Office Action Summary

10/032,082

WANG ET AL.

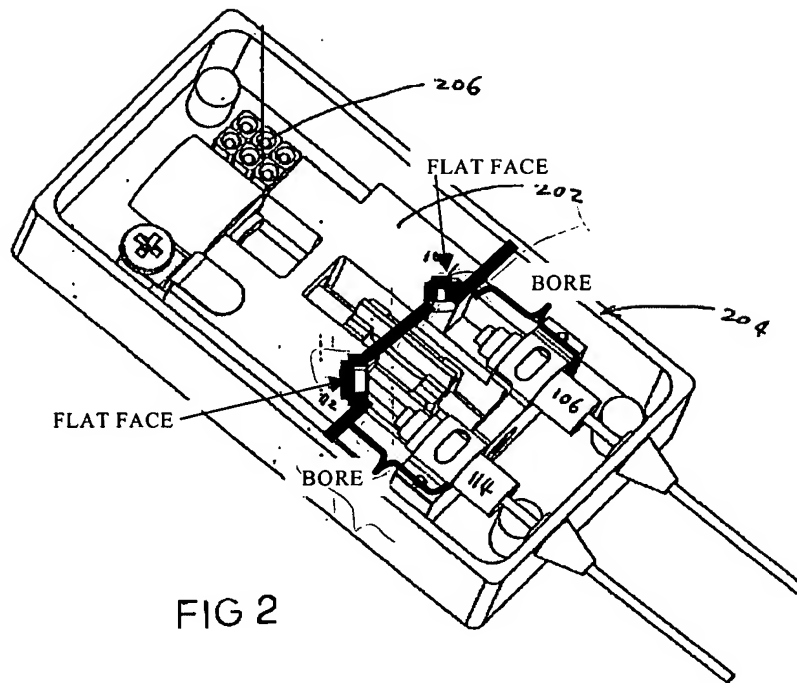
13. Applicant's arguments filed November 26, 2003 have been fully considered but they are not persuasive. Applicant states that the passage of Shi et al. does not intersect with the first and second primary bores, and that the first and second flat surfaces are not respectively located at a joint of the passage and the first and second primary bores.

14. As indicated in the figure below, the first and second bores are disposed on either side of the mount, extending from the collimators 106 and 114 to reflectors 108 and 112. The passage, the distal side of which is indicated in bold, intersects the bores at the flat faces as noted. Therefore, Shi et al. discloses the claimed limitations.
